YUKON ENERGY CORPORATION

**MINTO MINE PPA APPLICATION
INTERROGATORY RESPONSES**

March 8, 2007

10 SCHEDULE A & B are provided on 11" x 17" sheets in PWP-YEC-1-29 Attachment 1.

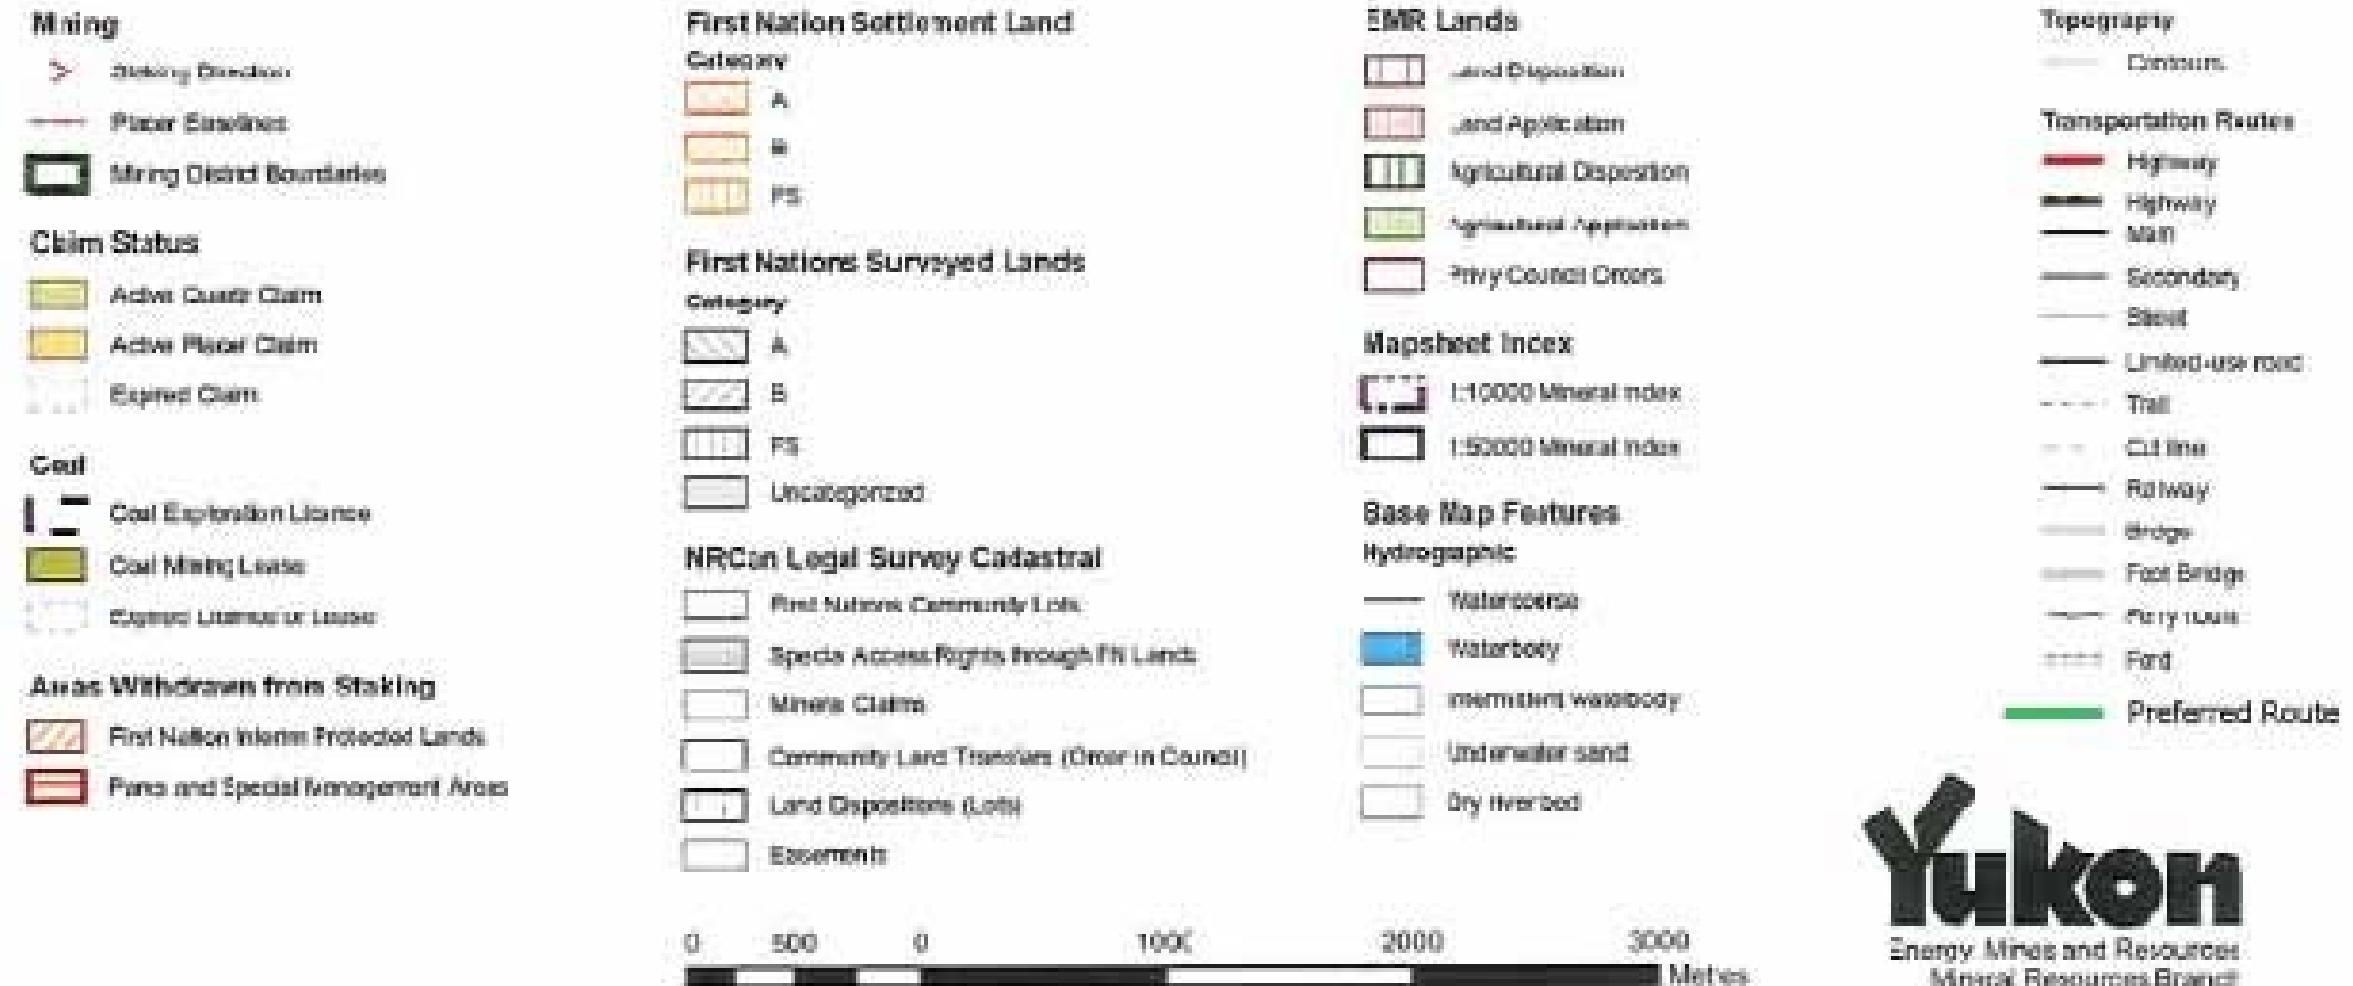
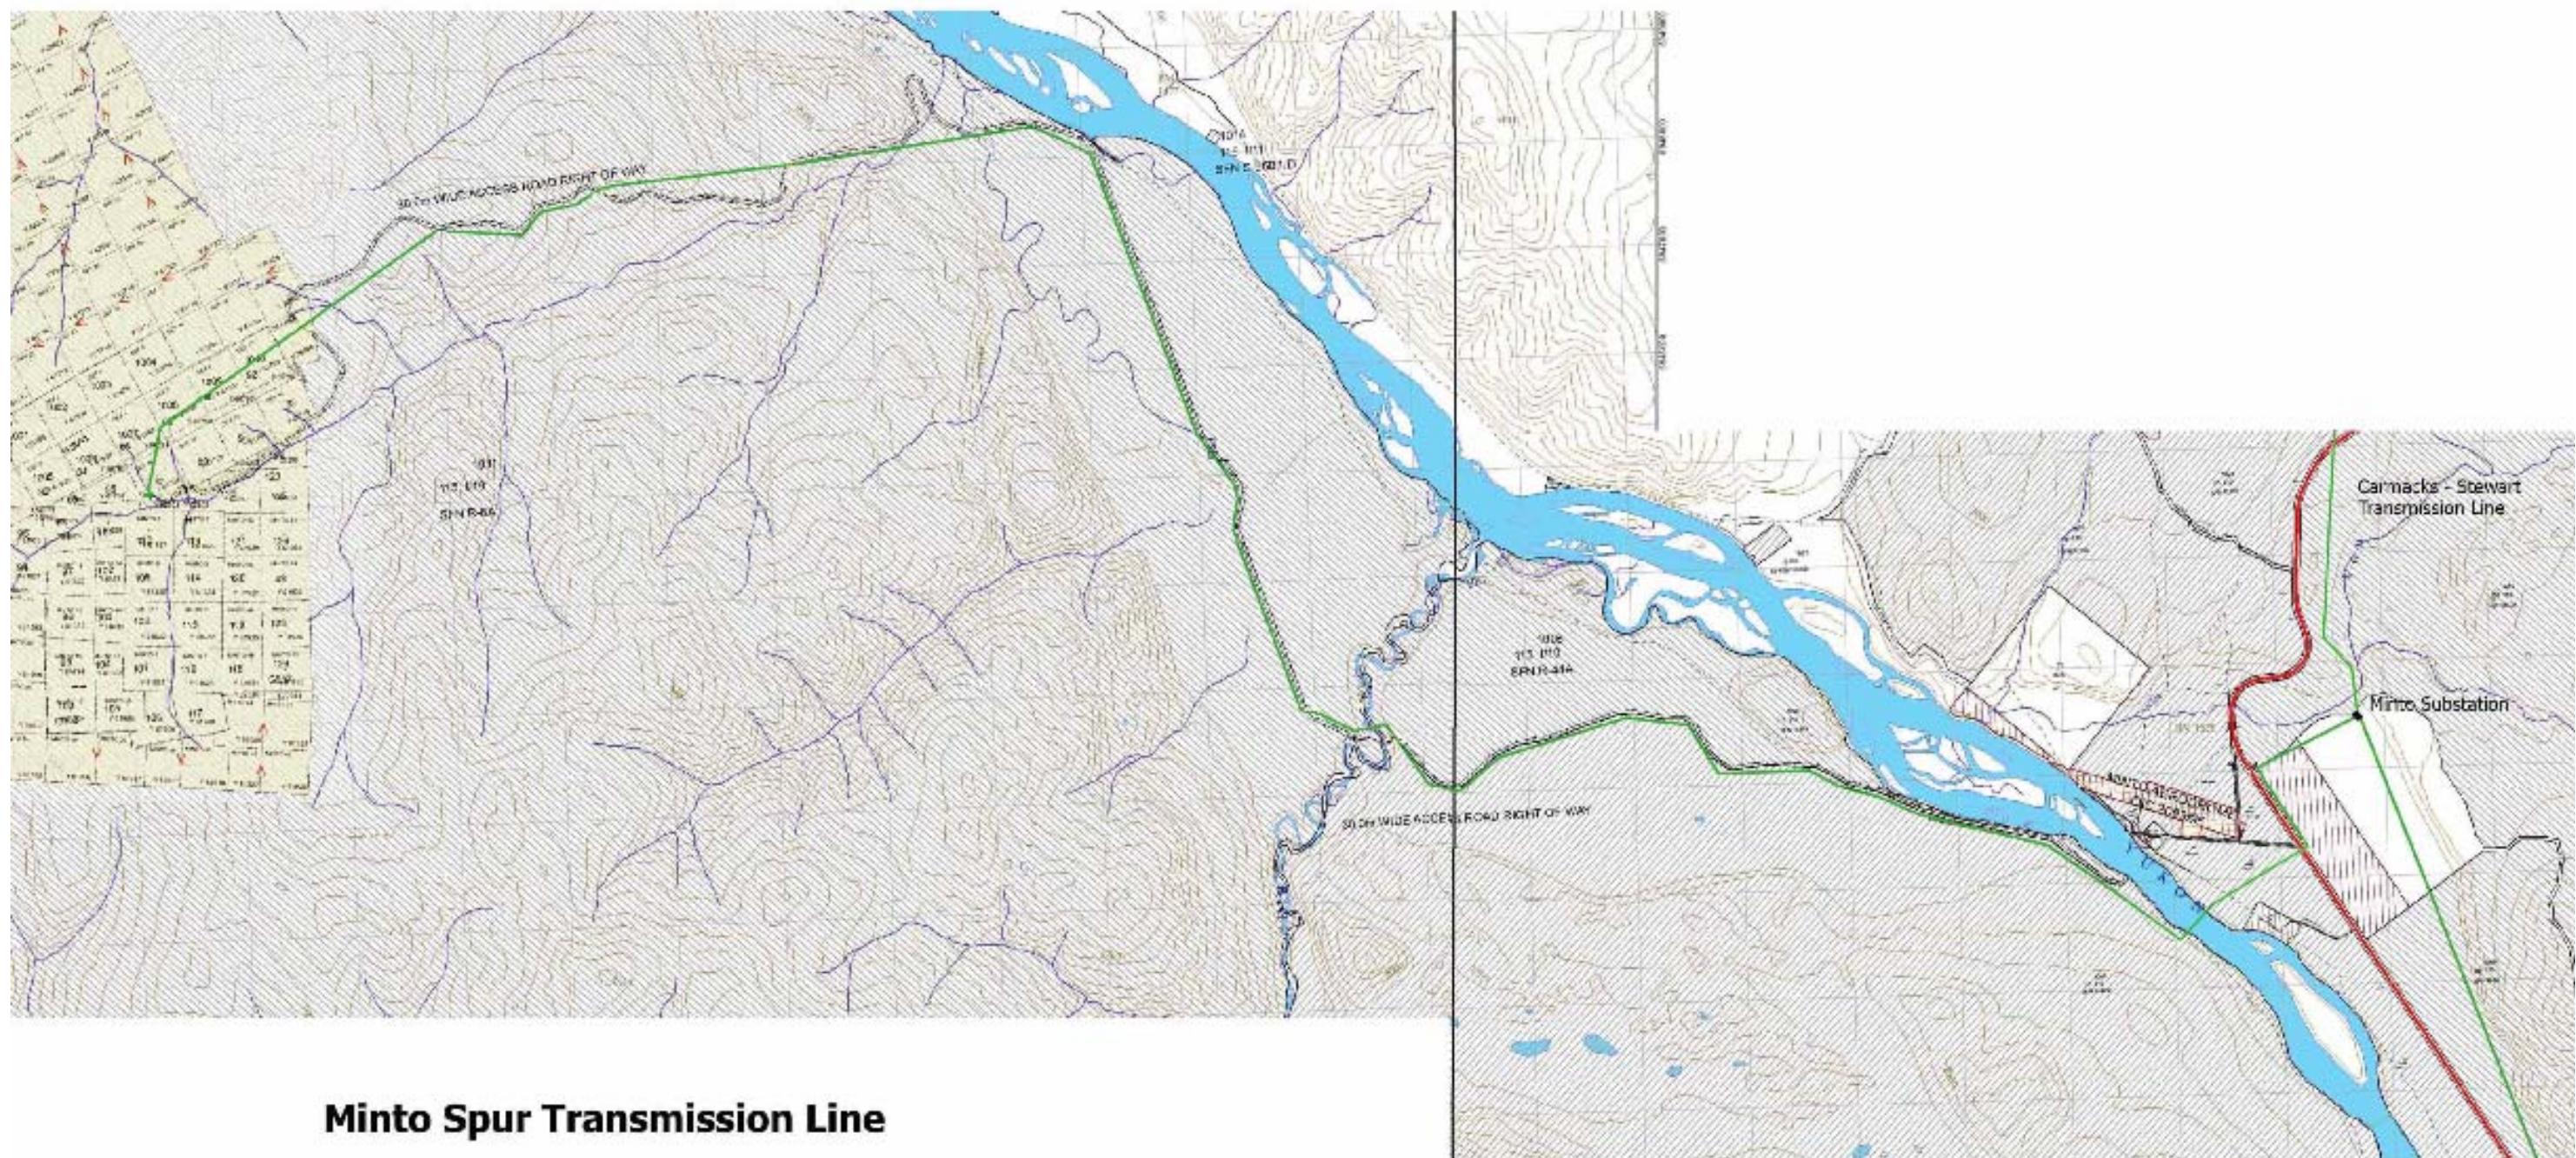
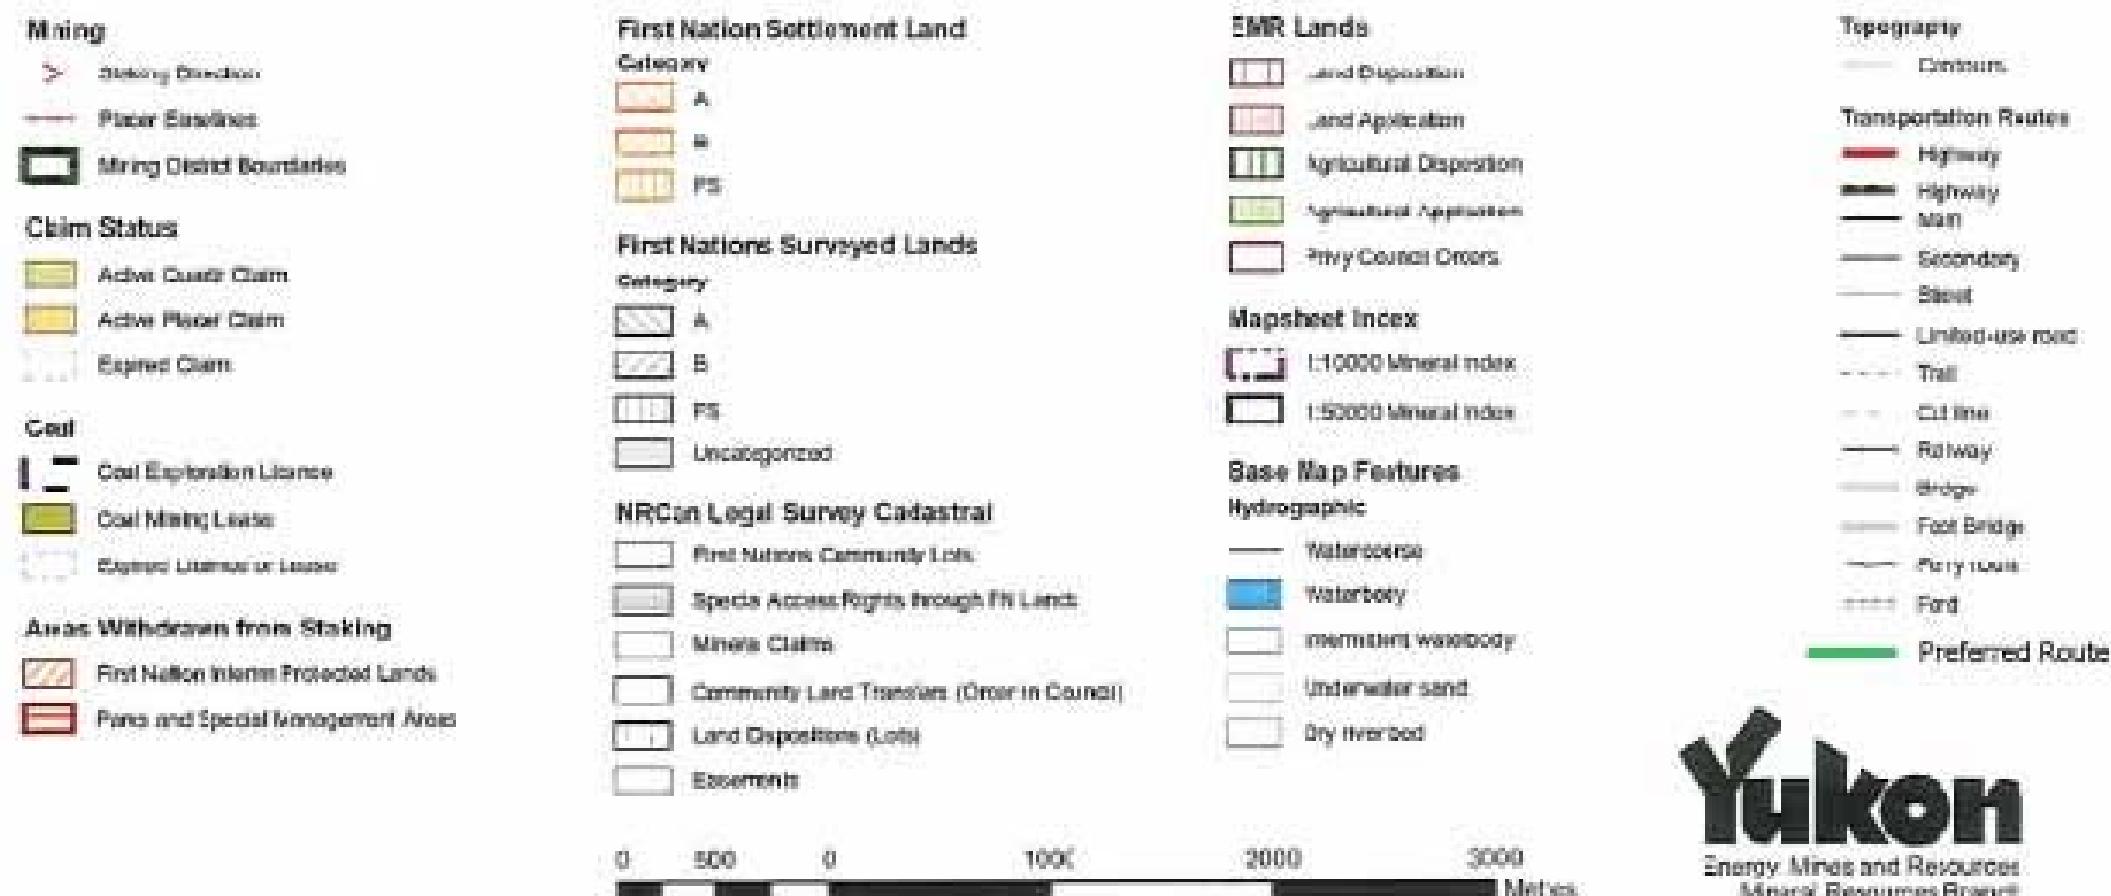
5 1. Please reproduce all the maps of SCHEDULE A & B on 11"x17" at a suitable
6 scale so that they can be seen by the naked eye.
